TECHNICAL SERVICE BULLETIN

Number: TSB-FC-2017-062

Symptom: Battery deactivated, 3 red flashes.

Identification label added on the machine box

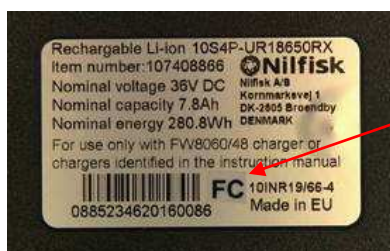
Battery with the new firmware uploaded and **FC** mark are fully compatible with the fast charger option (coming soon)

Reworked battery—add-on label

New production battery—print directly on the existing label.
